ADDENDUM NO. 002 (Rev 01/2017)

ISSUE DATE: **03/12/2024**

RE: **GRAINGER HALL 2ND & 5TH FLOOR RENOVATION
PHASE 2 - 5TH FLOOR OFFICE RENOVATION &
PHASE 3 - 2ND FLOOR NW CORNER RENOVATION
UNIVERSITY OF WISCONSIN-MADISON
610 WALNUT STREET
MADISON, WISCONSIN**

UWSA Project No. **A-22-021**
UW Madison Project No. **0140-2303**

Sheet Number: E401

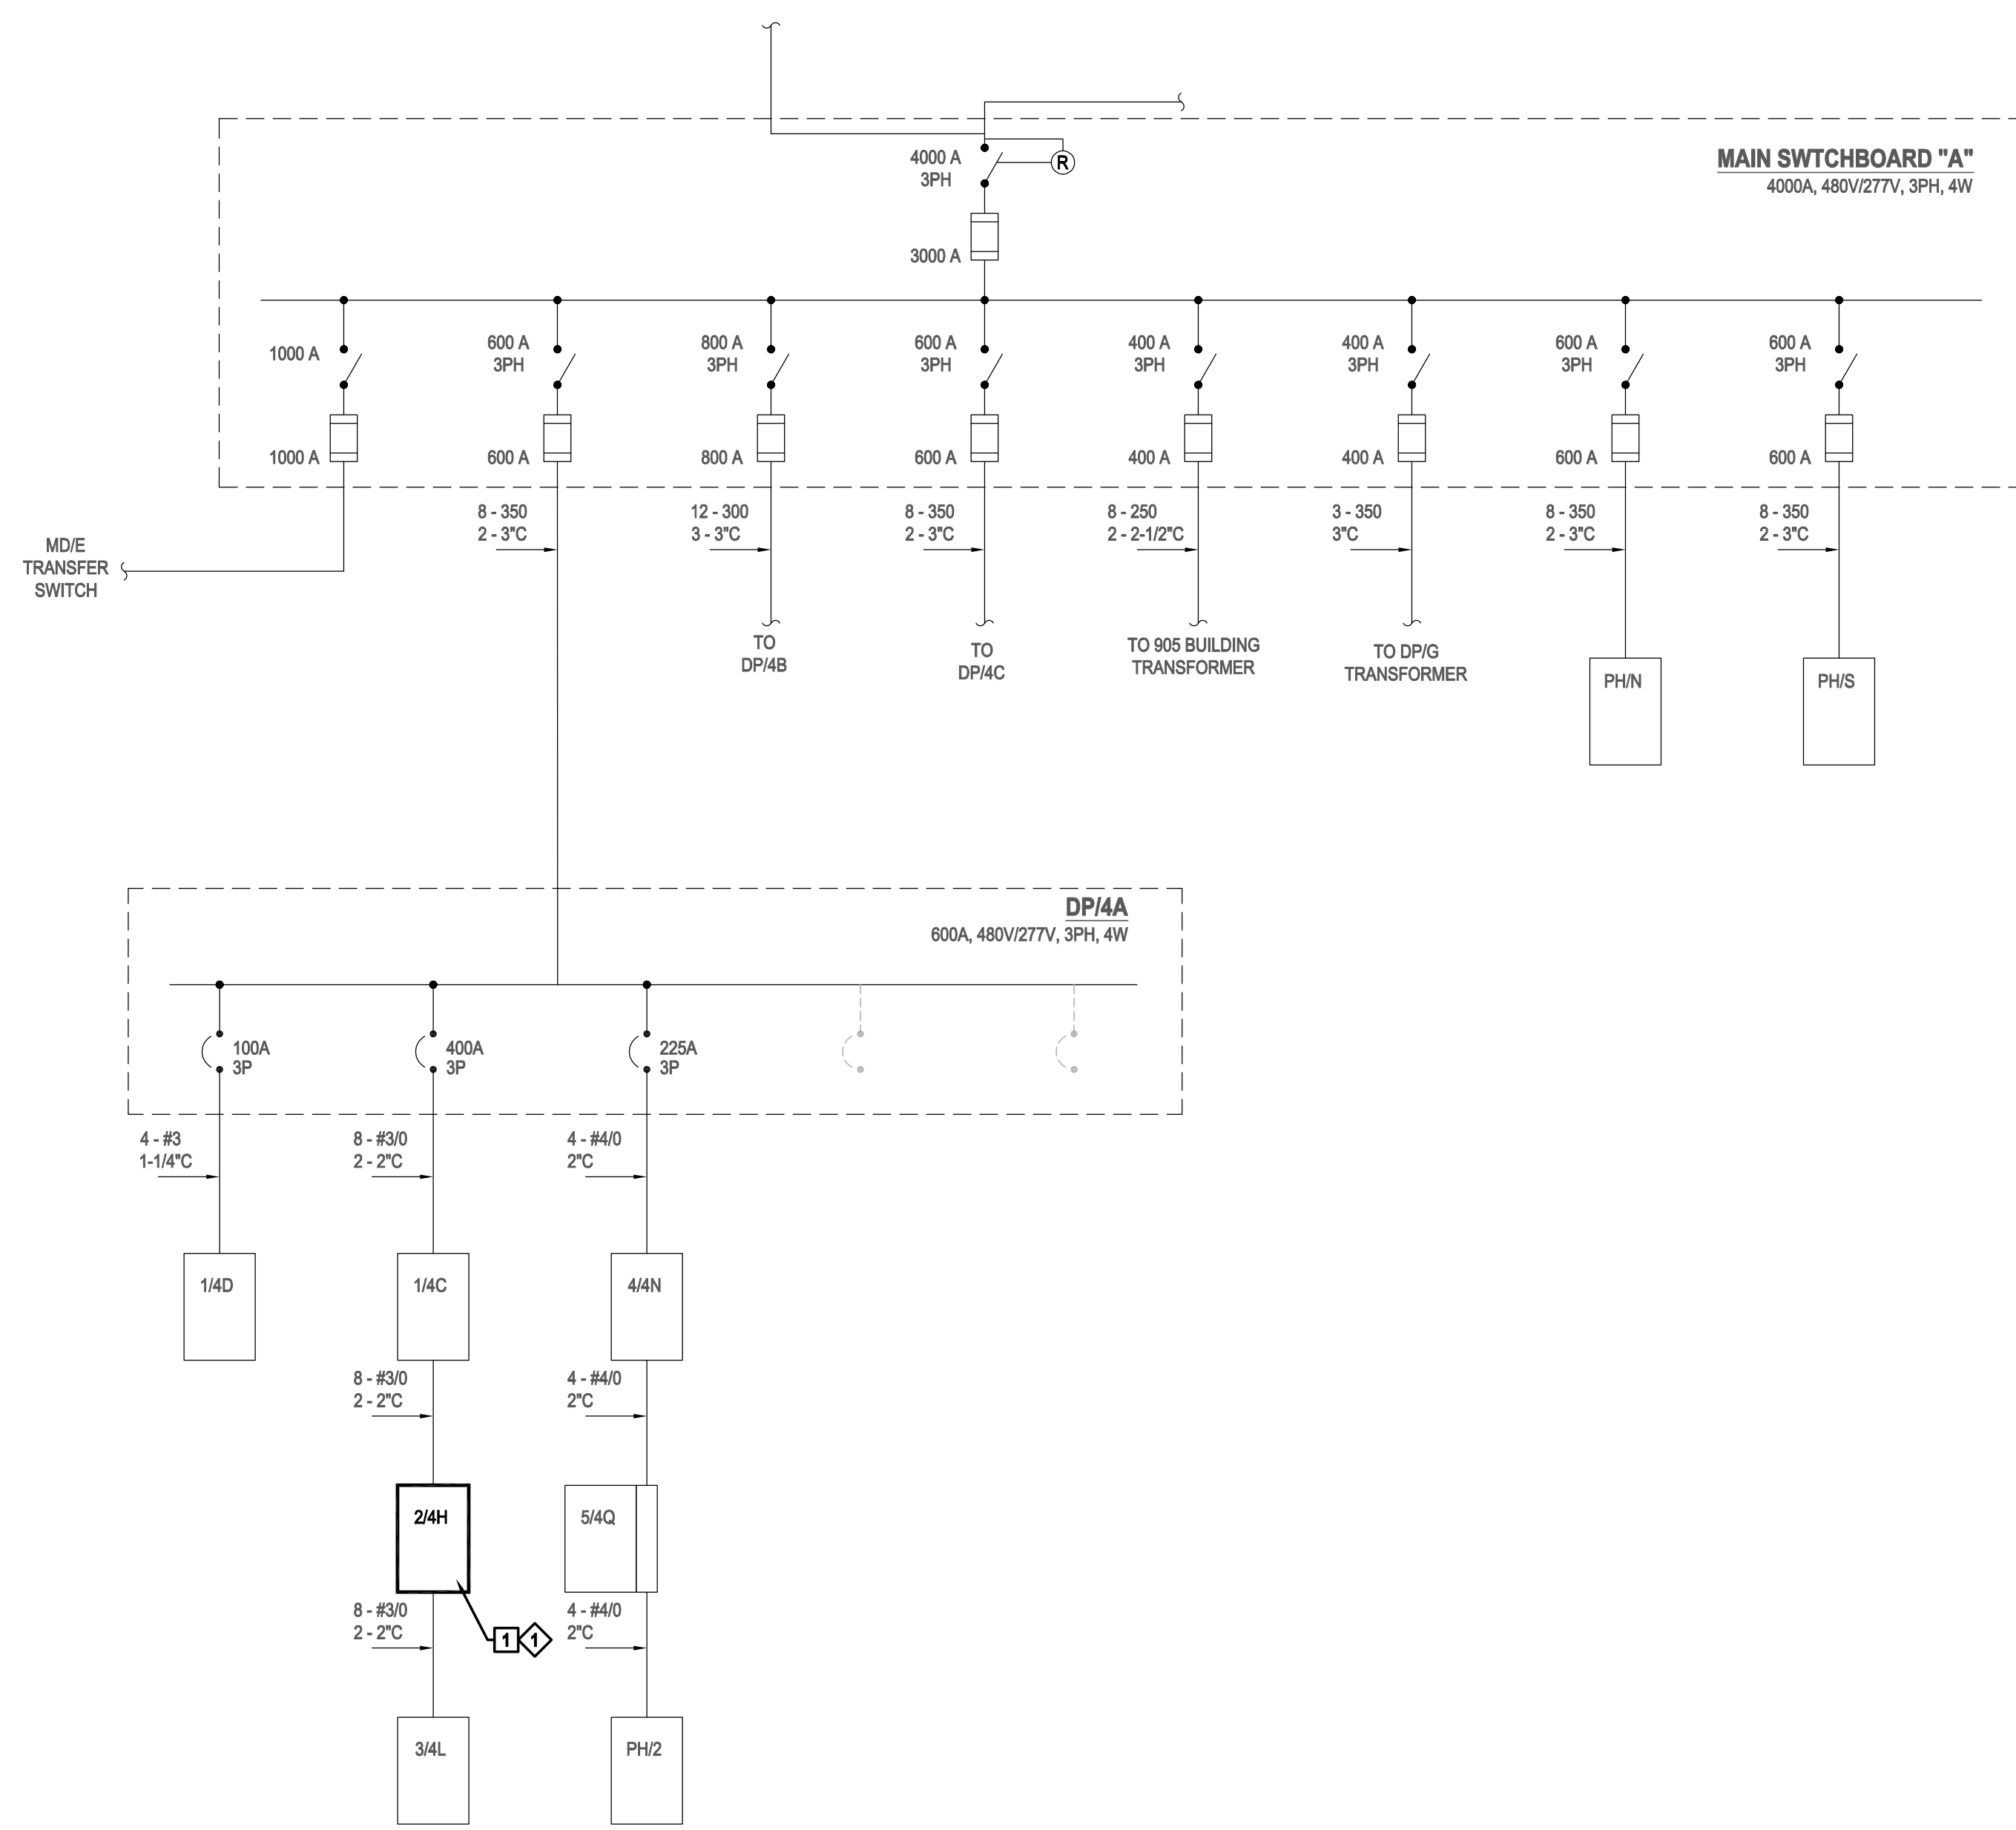
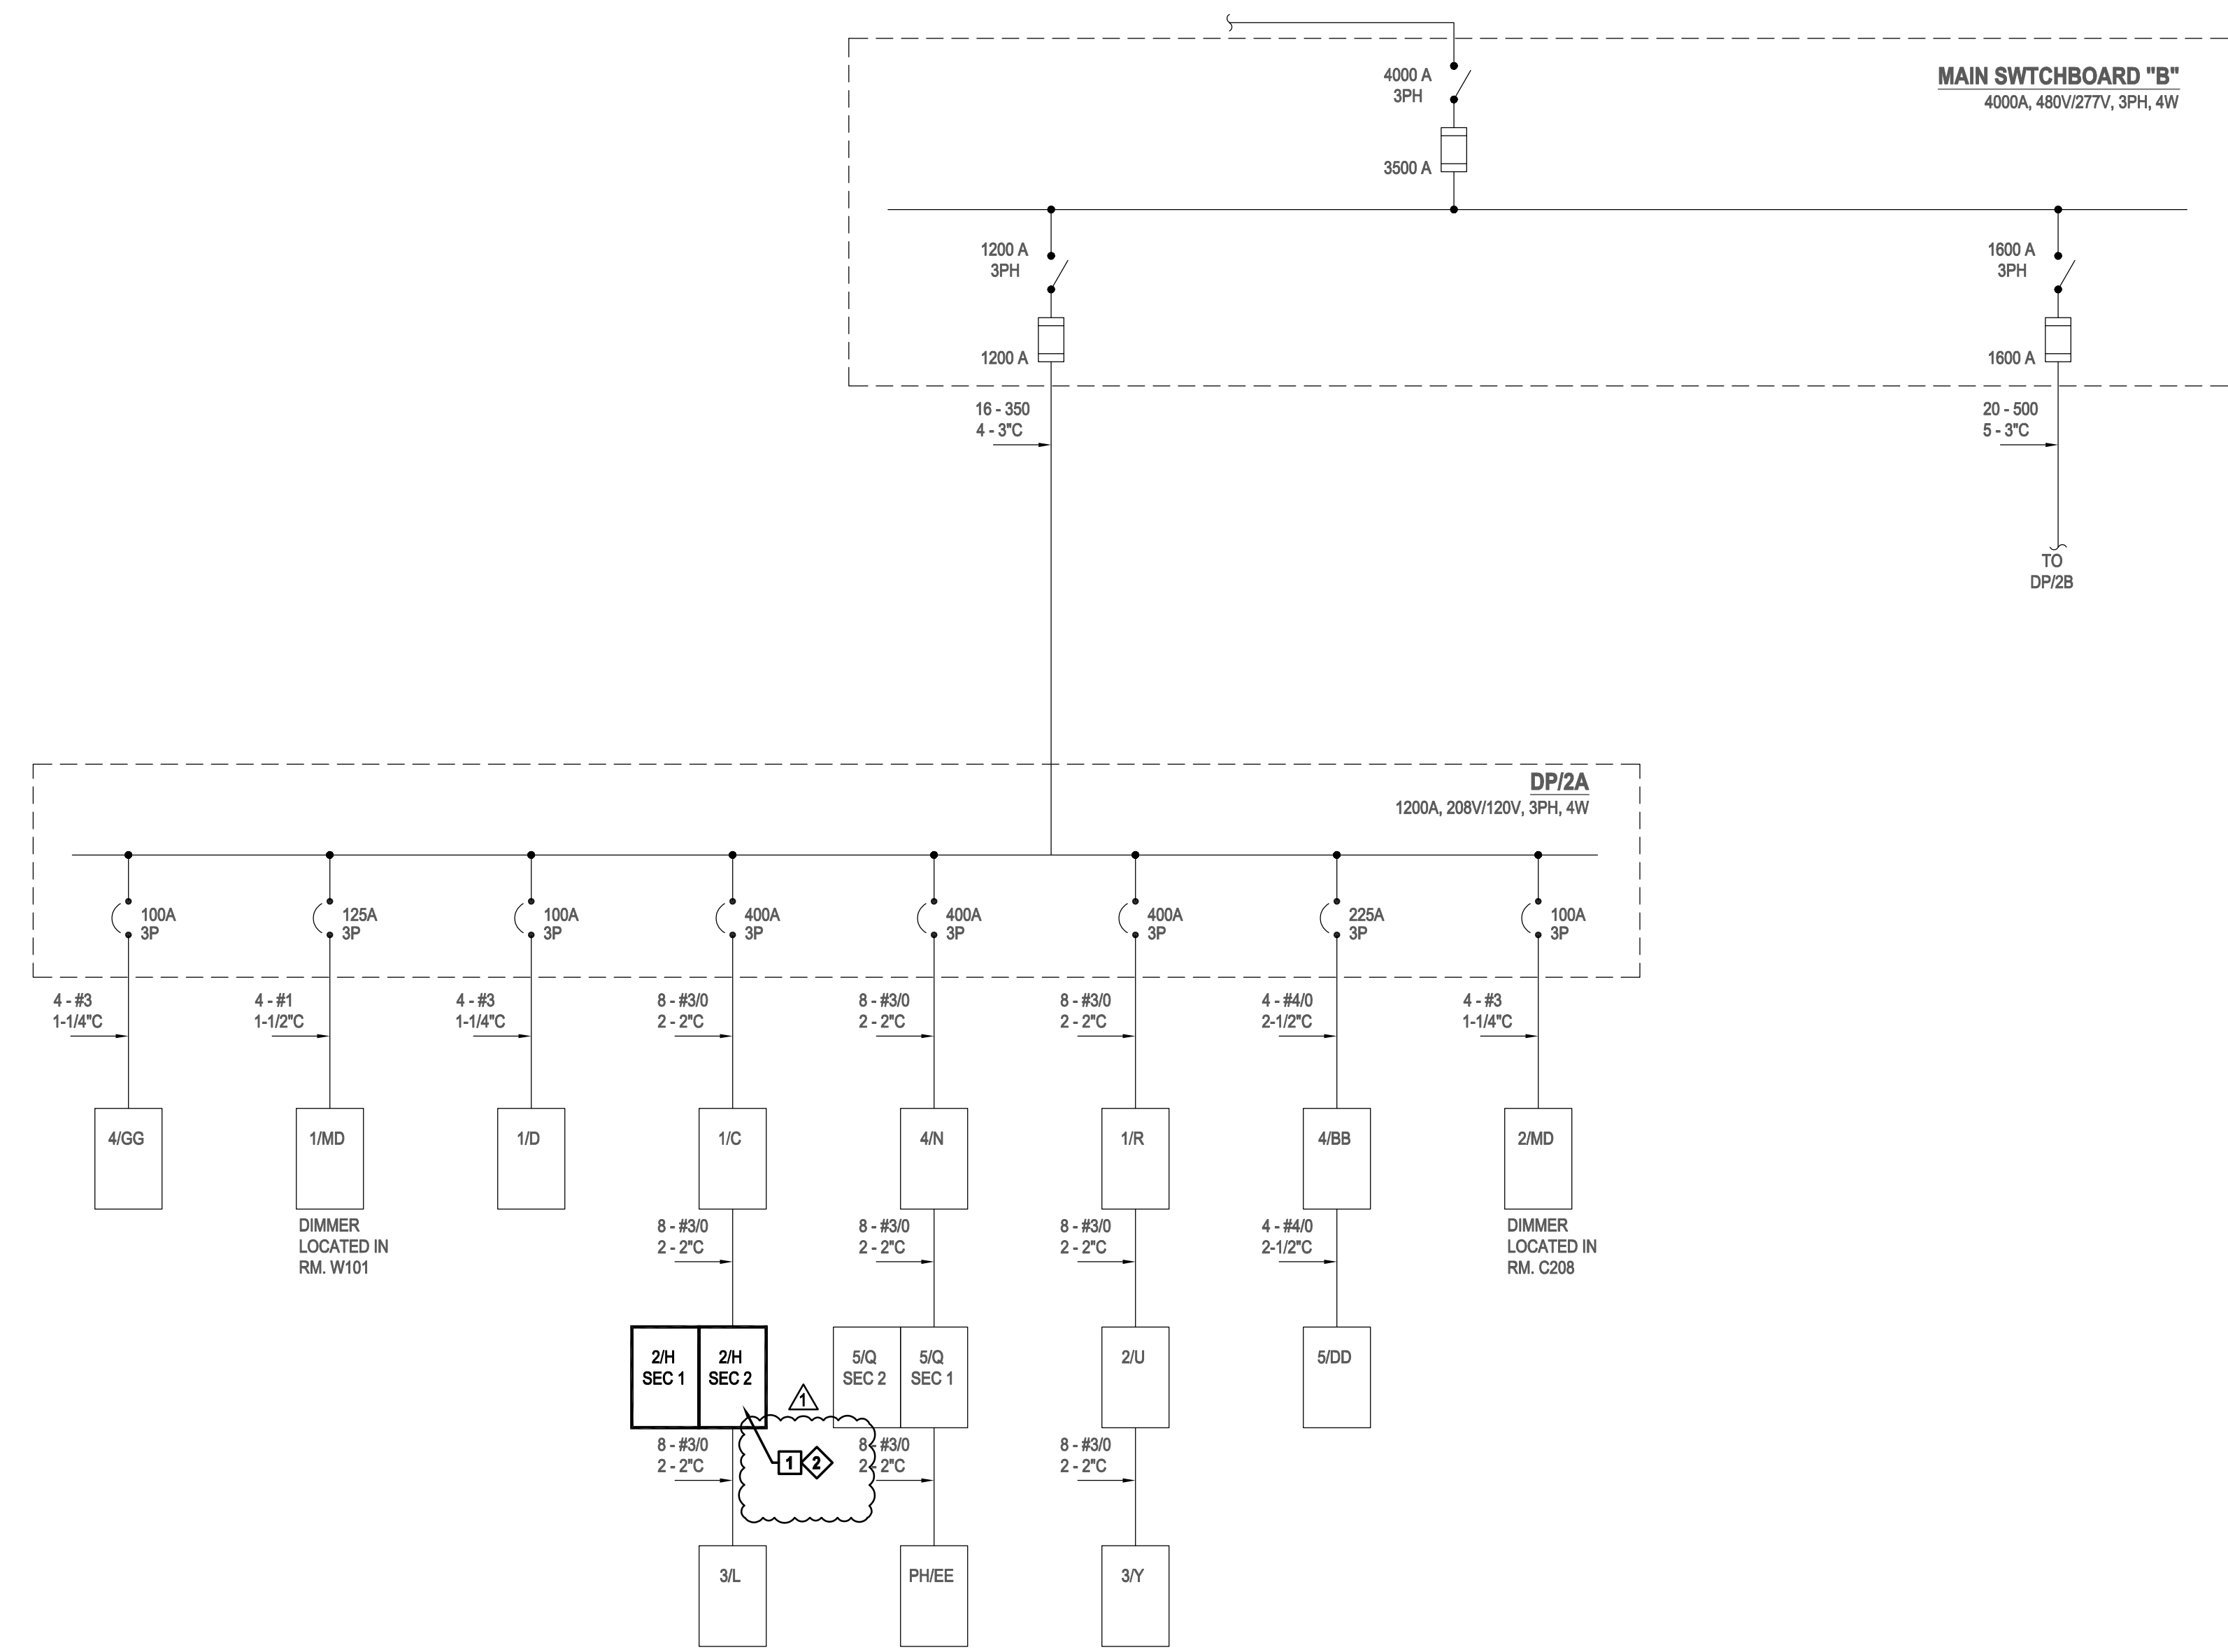
- e. Sheet E401
 - i. **REVISED:** Keyed Demolition Note 1. Note change to REMOVE AND REPLACE BUS AND BREAKERS TO REDUCE ARC FLASH PROTECTION REQUIREMENTS, COORDINATE WITH ONWER FOR OUTAGE SCHEDULE.

- ii. **ADD:** Keyed New Work Notes. Add keynote 2, INSTALL PANEL BUS AND BREAKERS TO REDUCE ARC FLASH PROTECTION REQUIRMENTS. PROVIDE 14KA AIC RATING FOR PANEL. COORDINATE WITH OWNER FOR OUTAGE SCHEUDLE. See Sheet E401.

- REMOVE AND REPLACE PANEL BUS AND BREAKERS TO REDUCE ARC FLASH PROTECTION REQUIREMENTS. COORDINATE WITH OWNER FOR OUTAGE SCHEDULE.

- INSTALL PANEL BUS AND BREAKERS TO REDUCE ARC FLASH PROTECTION REQUIREMENTS. PROVIDE 22KA AIC RATING FOR PANEL. COORDINATE WITH OWNER FOR OUTAGE SCHEDULE.
- INSTALL PANEL BUS AND BREAKERS TO REDUCE ARC FLASH PROTECTION REQUIREMENTS. PROVIDE 14KA AIC RATING FOR PANEL. COORDINATE WITH OWNER FOR OUTAGE SCHEDULE.
